## **ANALYSIS**

### **INTER-DEPARTMENTAL REVIEW COMMENTS**

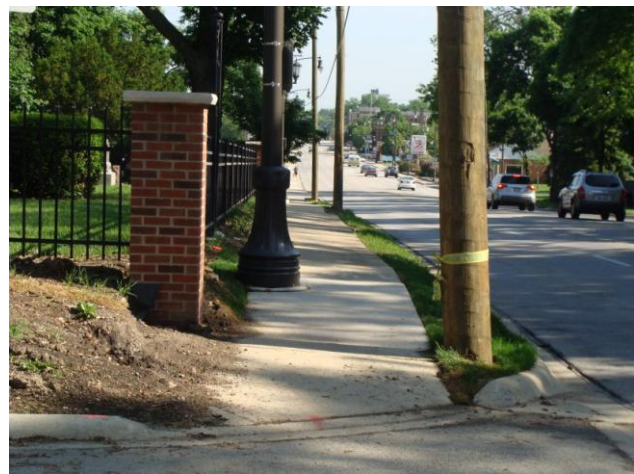
As part of the replacement, six brick pillars were reconstructed at their original dimensions and locations. However, as these pillars were non-conforming structures, reconstruction would require that new pillars meet all code requirements. The new pillars are approximately nineteen and one half inches (19.5") in width with a stone cap at the top that is approximately two feet (2') in width. The Zoning Ordinance requires that supporting members of a fence within the clear line of sight area be no greater than six inches (6") in width. Two of the reconstructed pillars are within clear line of sight areas. These two pillars are located at the intersections of Washington Boulevard and Main Street, one at the northern intersection and one at the southern intersection. As the width of these pillars exceeds six inches (6"), a variation is necessary.

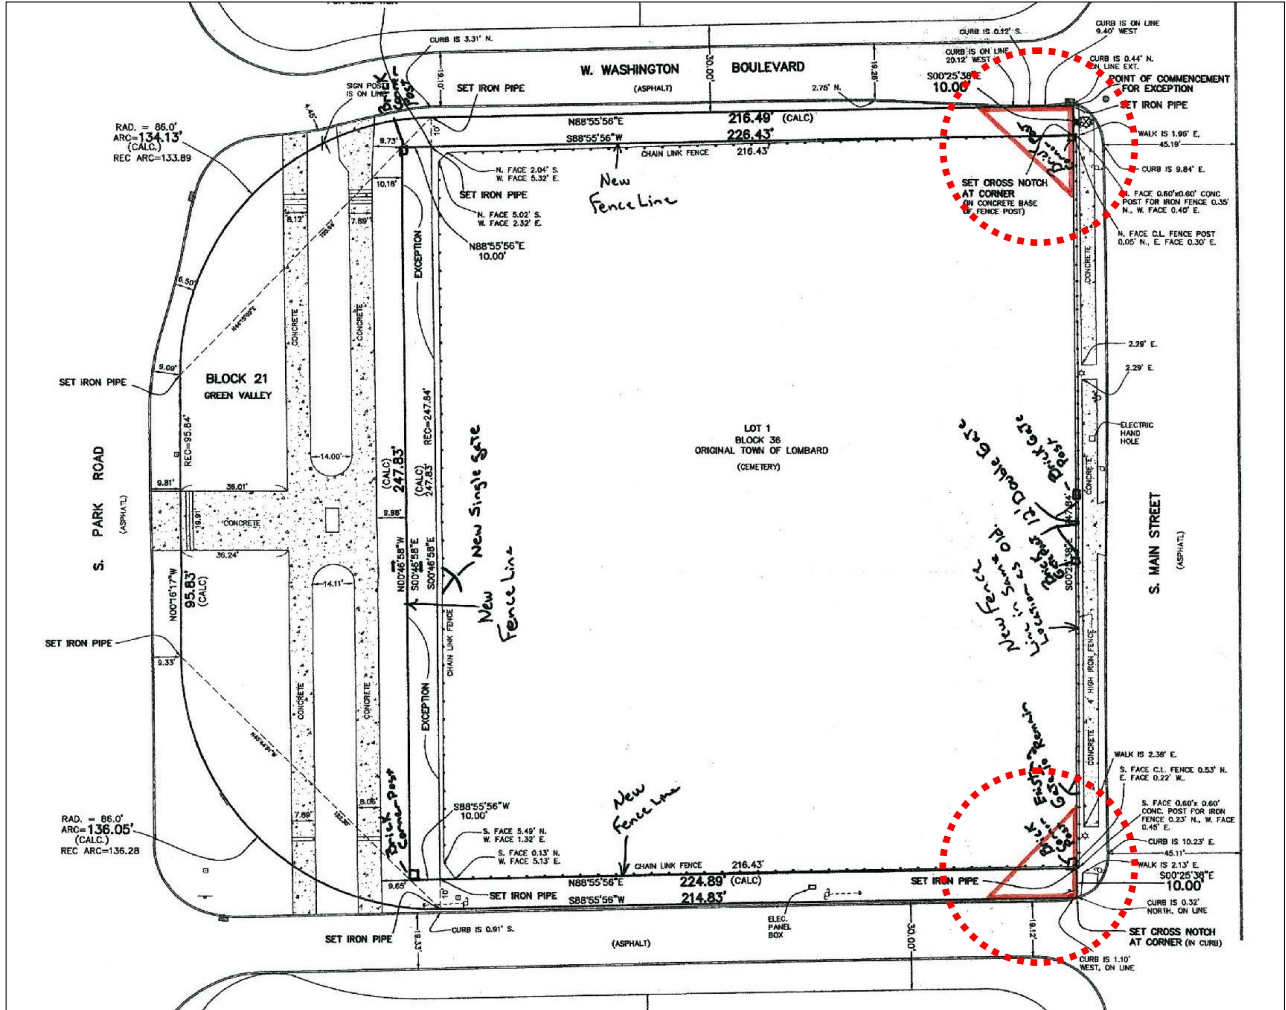
The above plan shows the location of these pillars within clear line of sight triangles (in red). Currently, the pillar on the northern side of the cemetery is of minimal concern regarding visibility as the northern side of Washington Boulevard allows only one way westbound traffic. The pillar on the southern side of the cemetery could block some visibility to and from Main Street as the southern side of Washington Boulevard allows only one way eastbound traffic. However, as the pillars previously existed, no additional reduction in visibility should occur.

Staff is supportive of the proposed variation due to the historic nature of the site, the previously existing fence and pillars, and necessity to fence in all existing burial plots.
